## REMARKS/ARGUMENTS

This reply is responsive to an Office Action mailed on December 8, 2004. Claims 1-21 were pending in the application.

Application Number 10/650,263  
Amendment Dated March 8, 2004  
Reply to Office action of December 8, 2004  
Annotated Sheet Showing Changes

FIG. 1

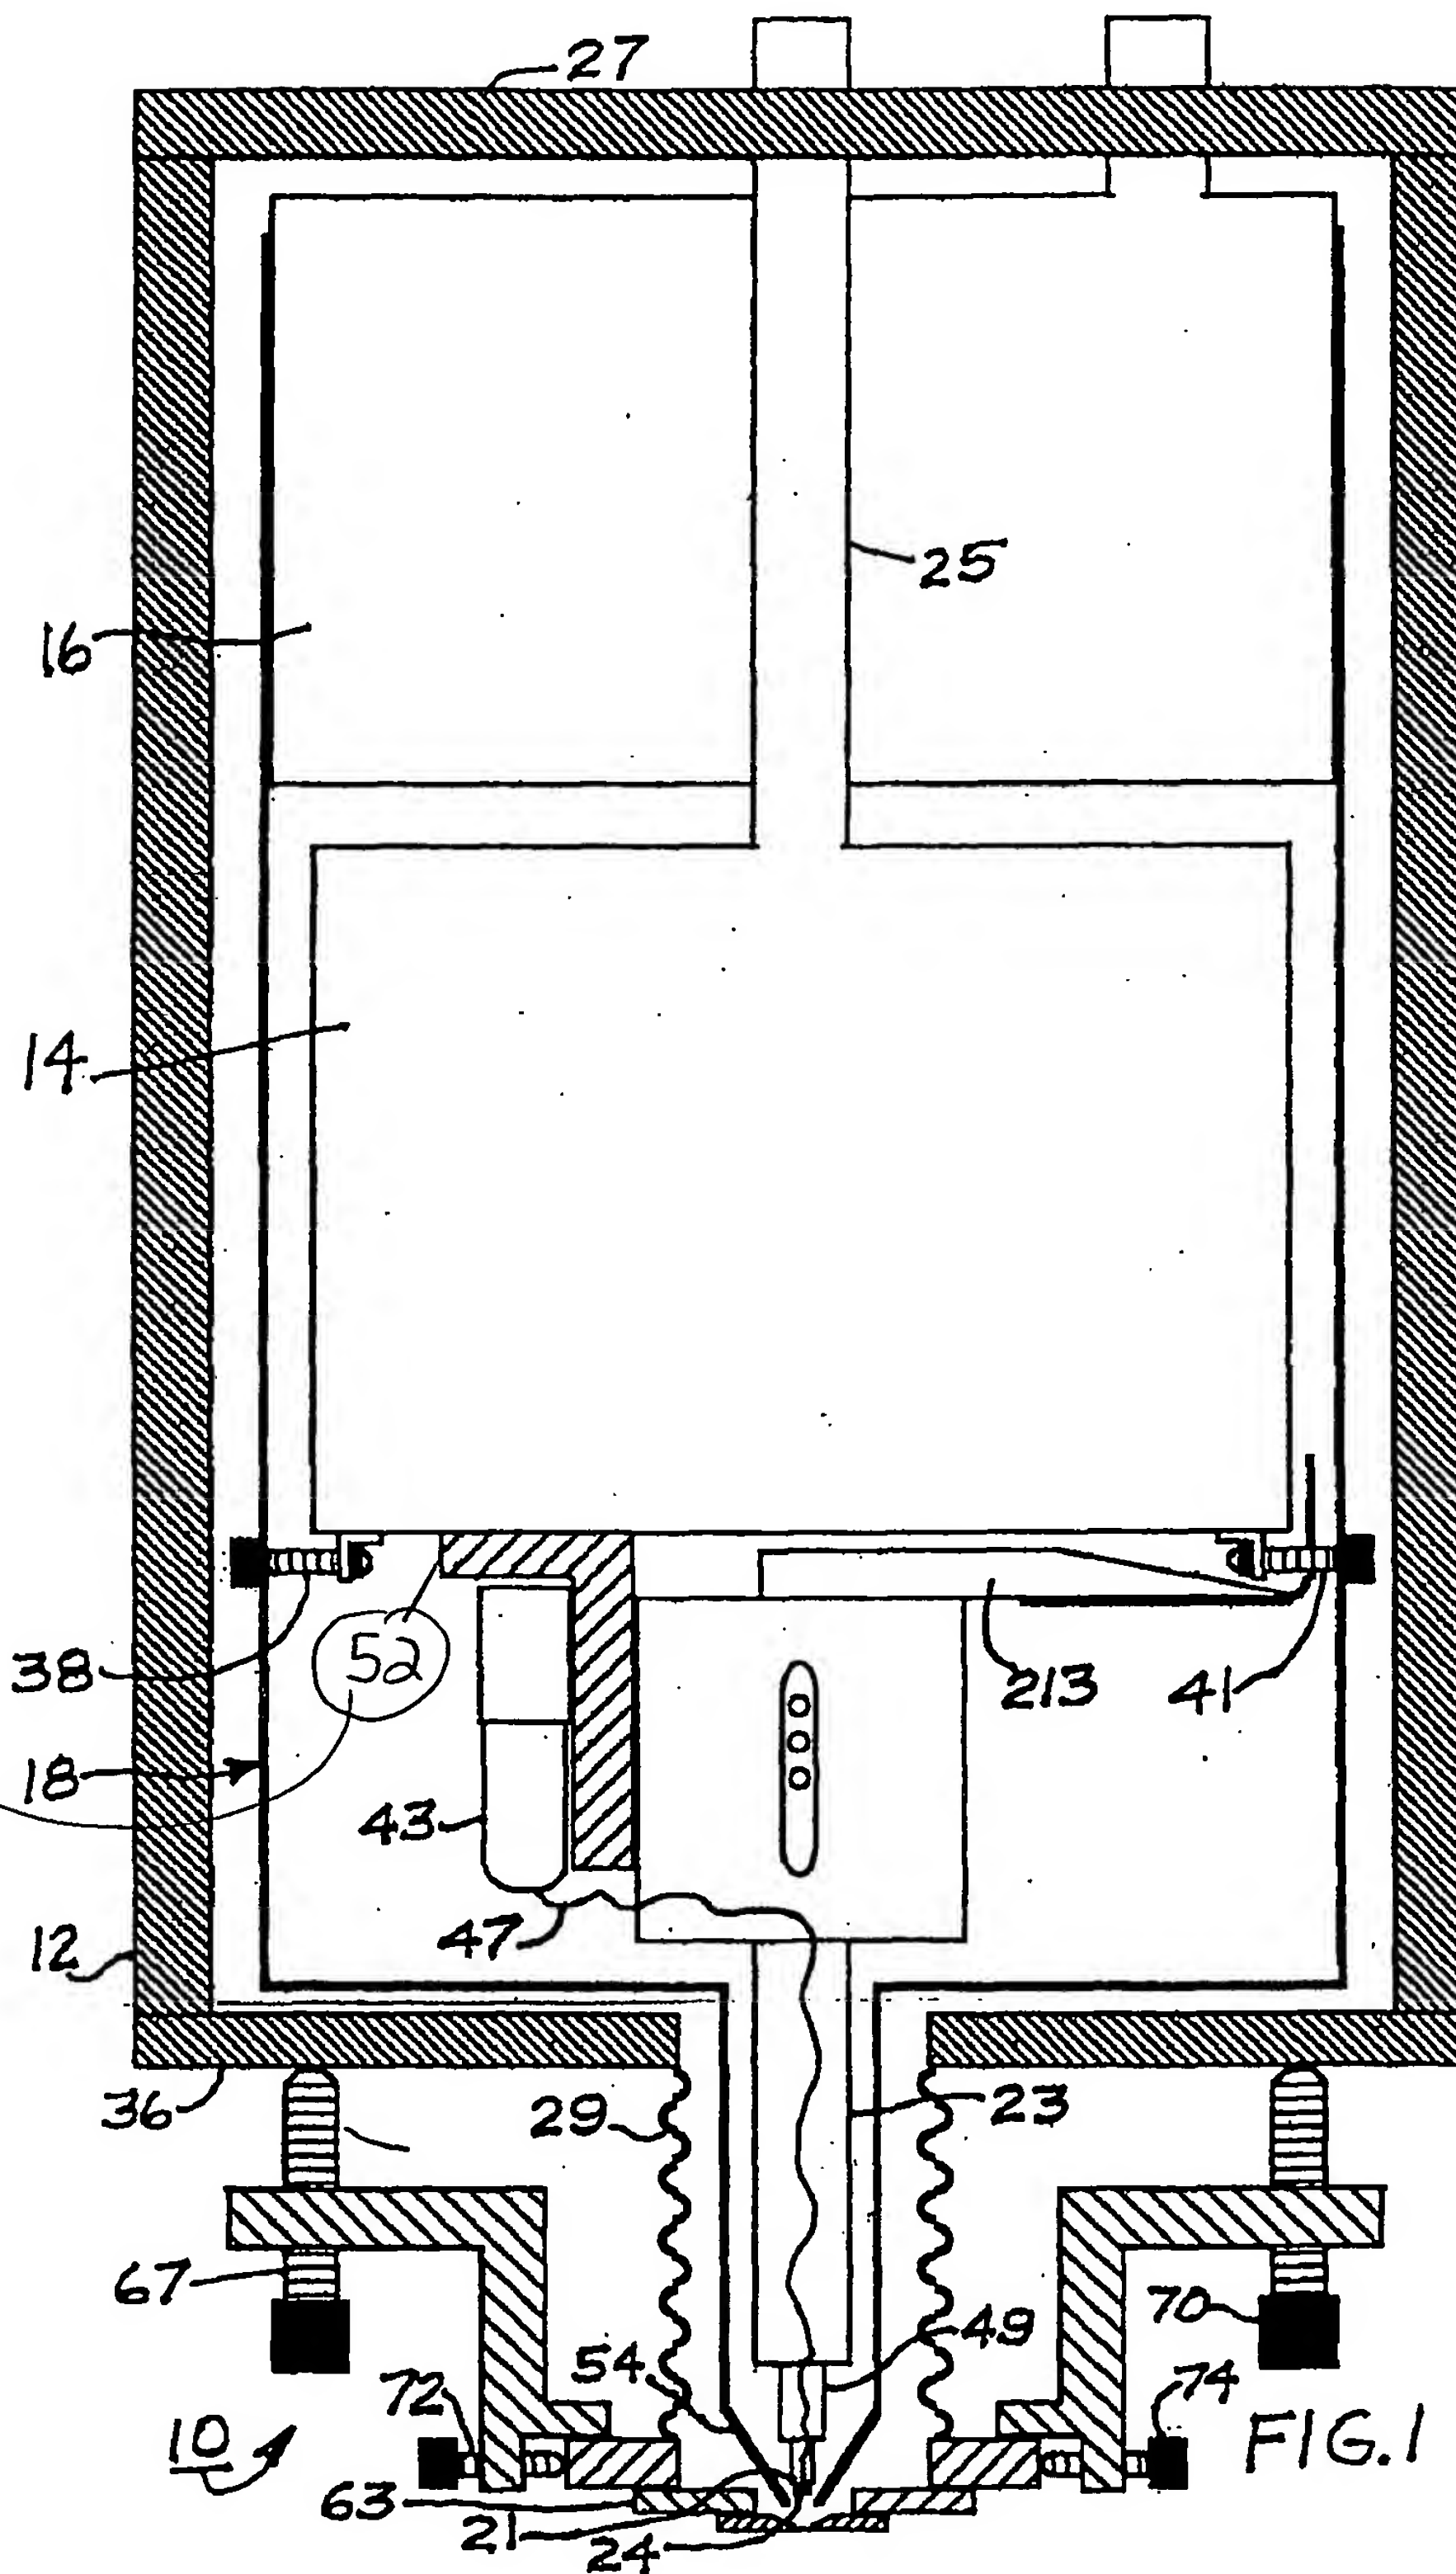
The drawings have been objected to as failing to comply with 37 CFR 1.84(p)(5) because they do not include reference signs mentioned in the description, namely the cold plate 52 and the motor 87.

Replacement sheets for Figure 1 and Figure 5 with an annotated sheet showing changes for these two figures have been provided. Figure 1 now shows the reference sign for the cold plate 52 and Figure 5 now shows the reference sign for the motor 87.

The attached drawing sheets include changes to Figure 1 and Figure 5. These sheets replace their respective original sheets. In Figure 1, previously omitted reference character 52 has been added, and in Figure 2, previously omitted reference character 87 has been added.

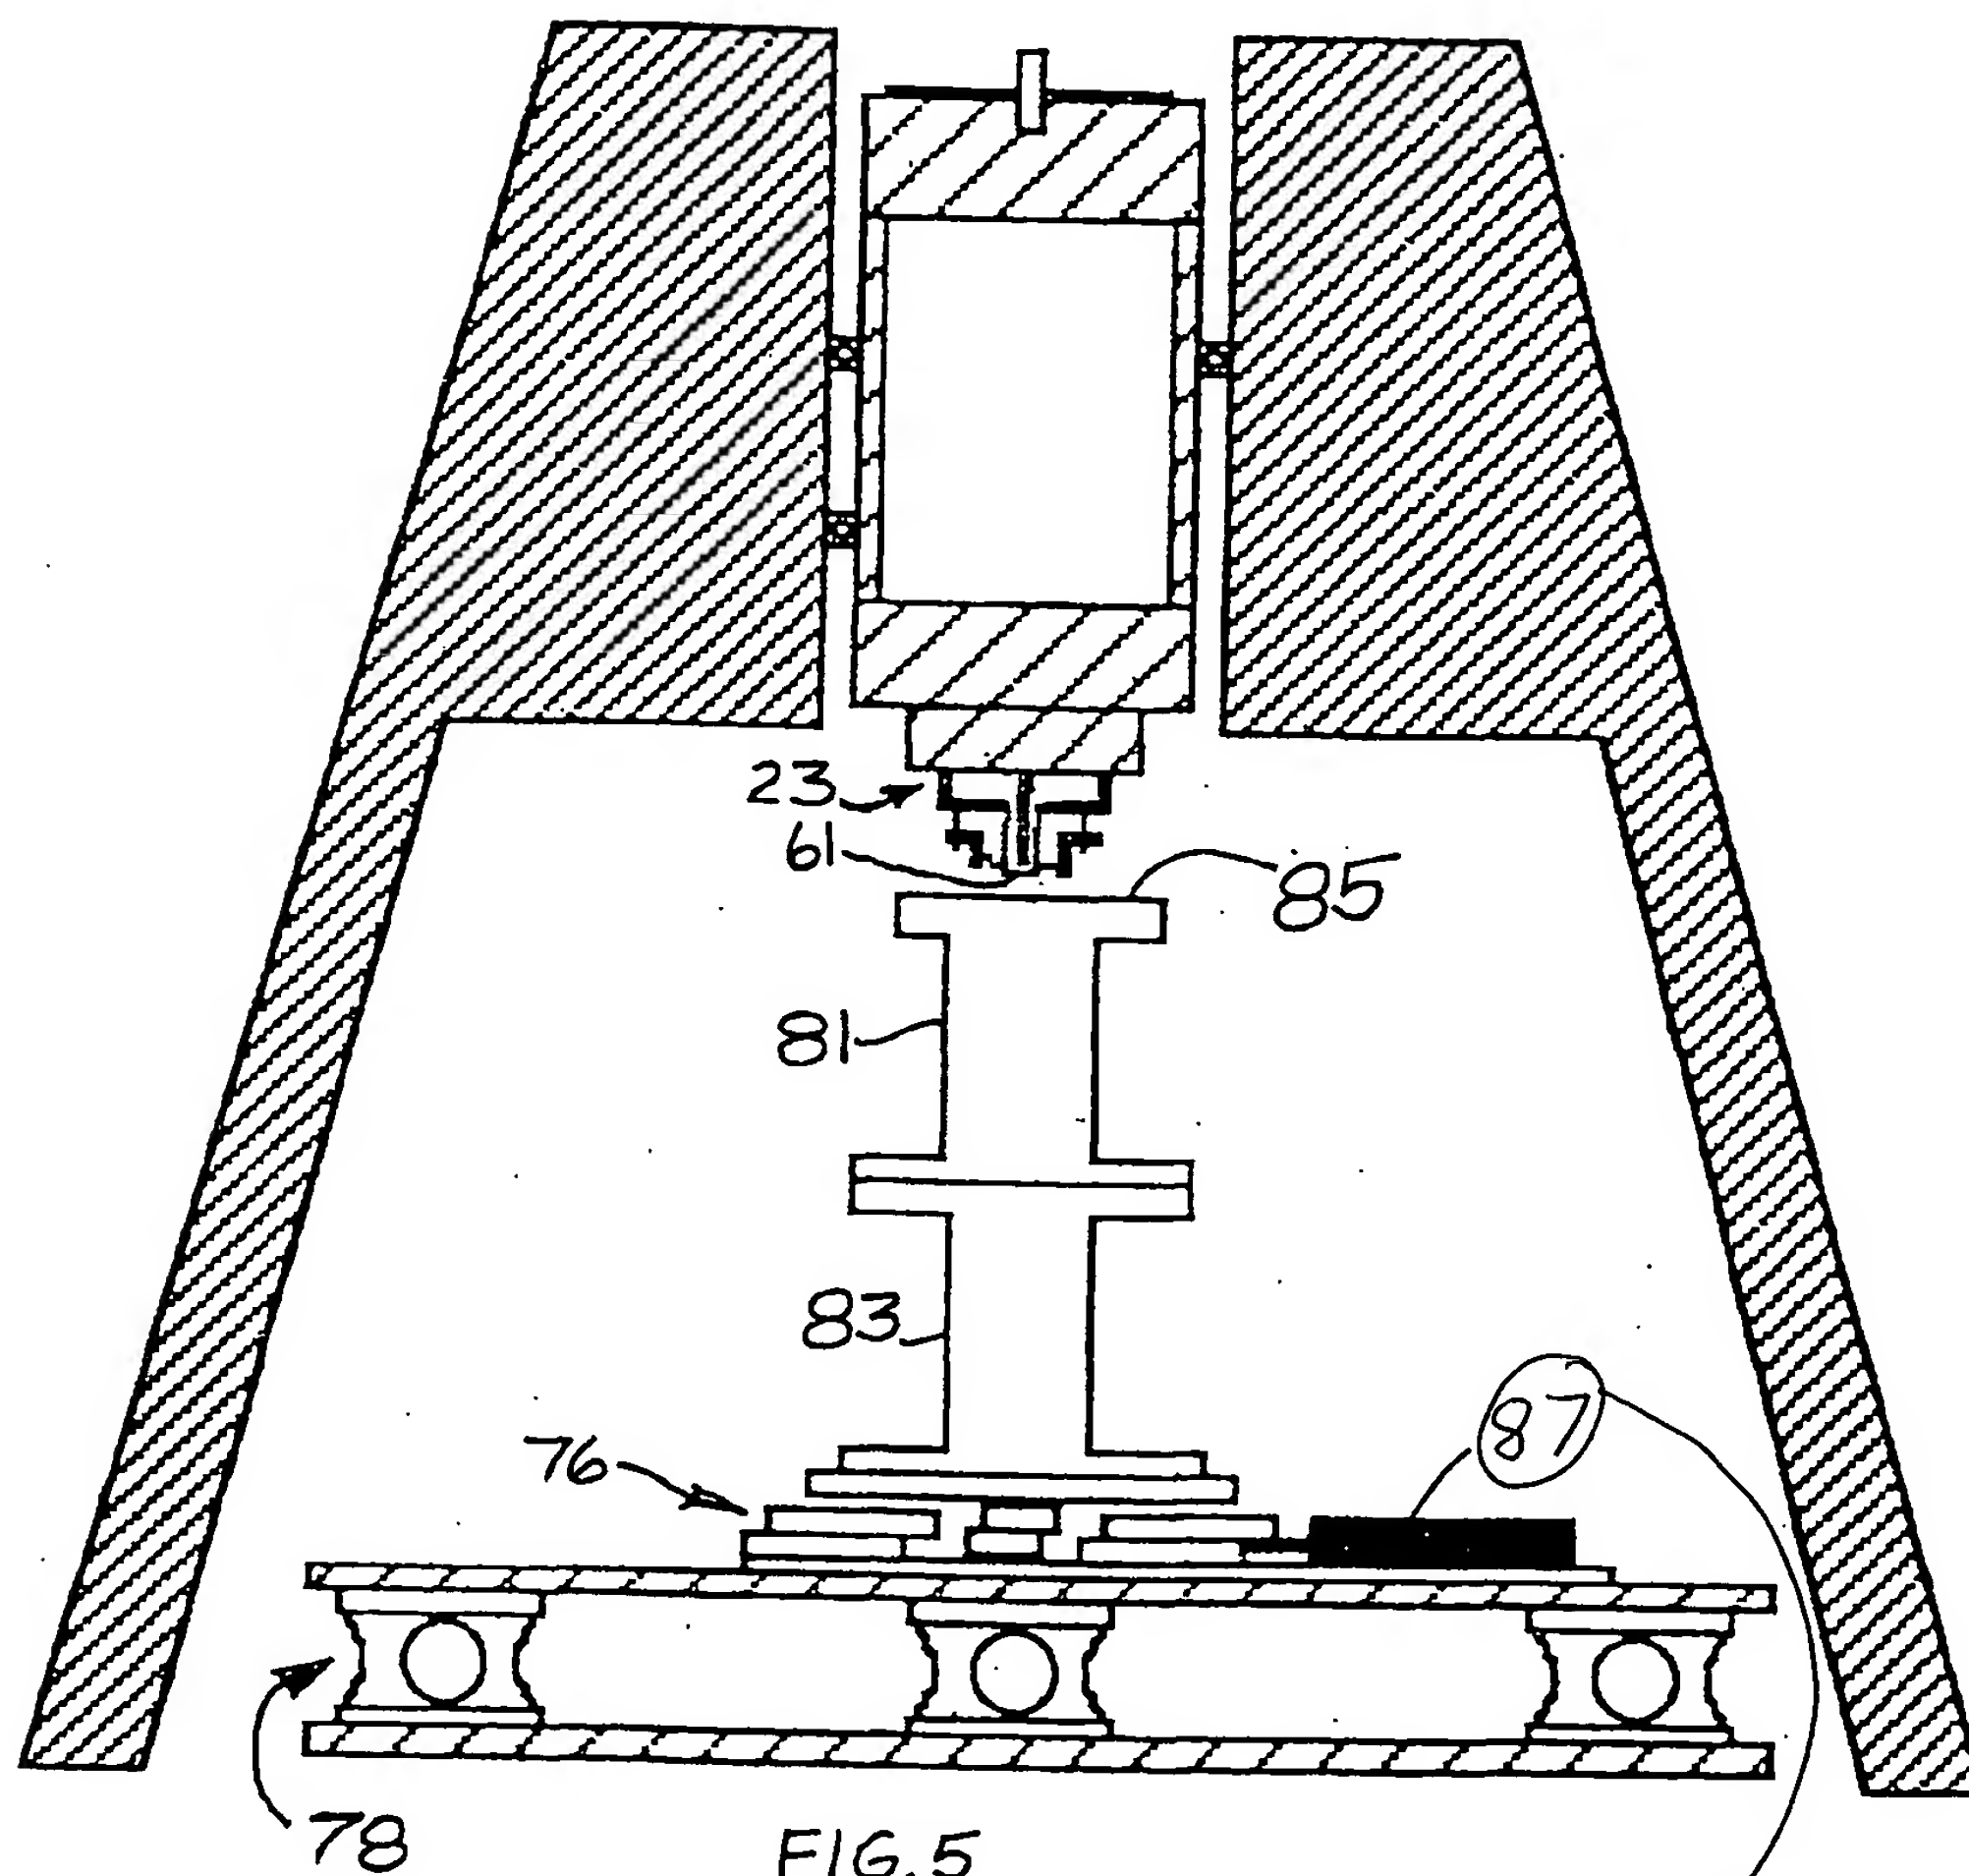
Element 87  
added to the  
drawings.
